DRIVER'S JACKET HOOK Prevost vehicles

On the vehicles affected by this bulletin, remove the existing jacket hooks and install one new hook.

FIGURE 1

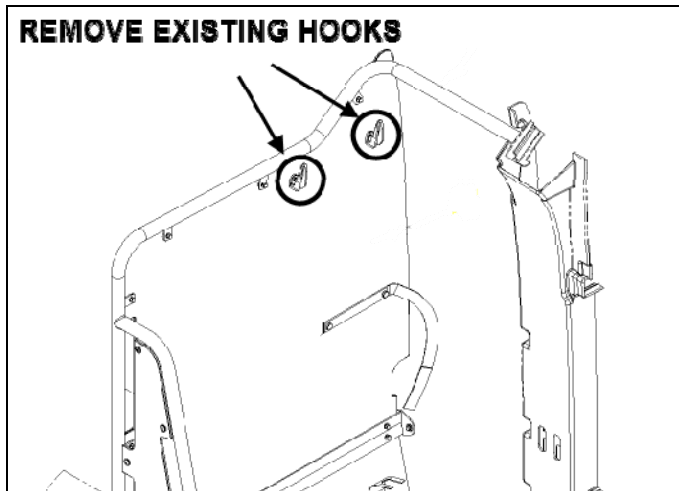
- 1) Locate the modesty panel. Behind the driver's seat, remove the existing hooks (2x) (figure 1).

FIGURE 2

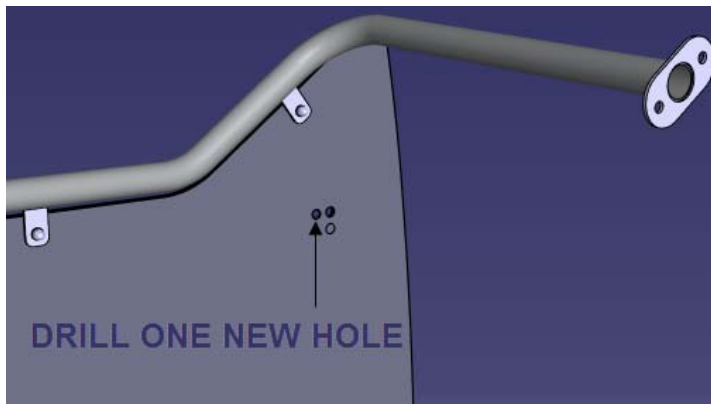
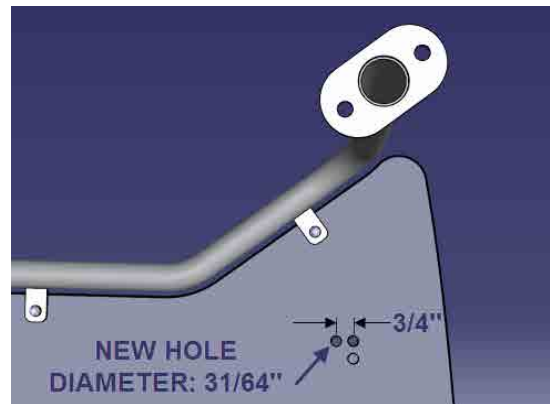
- 2) Where was located the hook closer to the side window, drill a new hole horizontally located at the left of the existing one (figures 2 & 3).

FIGURE 4

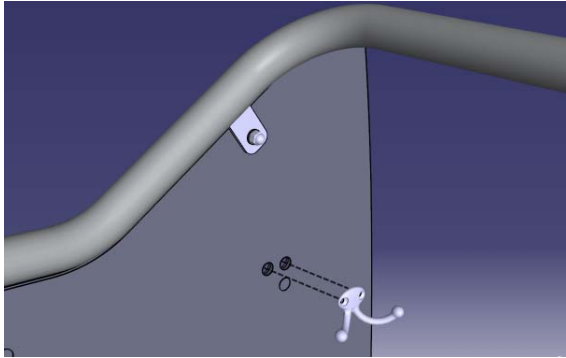
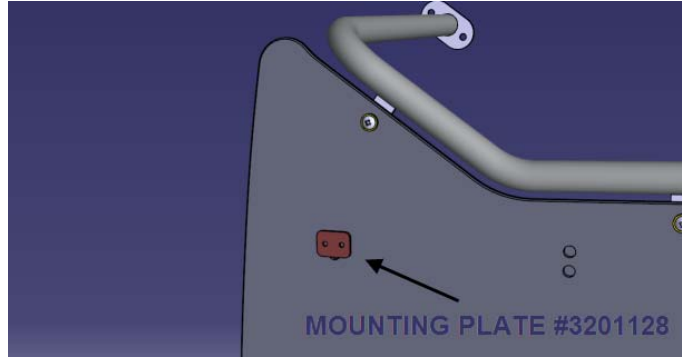
- 3) Install new hook using two screws #500371 and the mounting plate #3201128 (figures 4 & 5) on the other side of modesty panel.
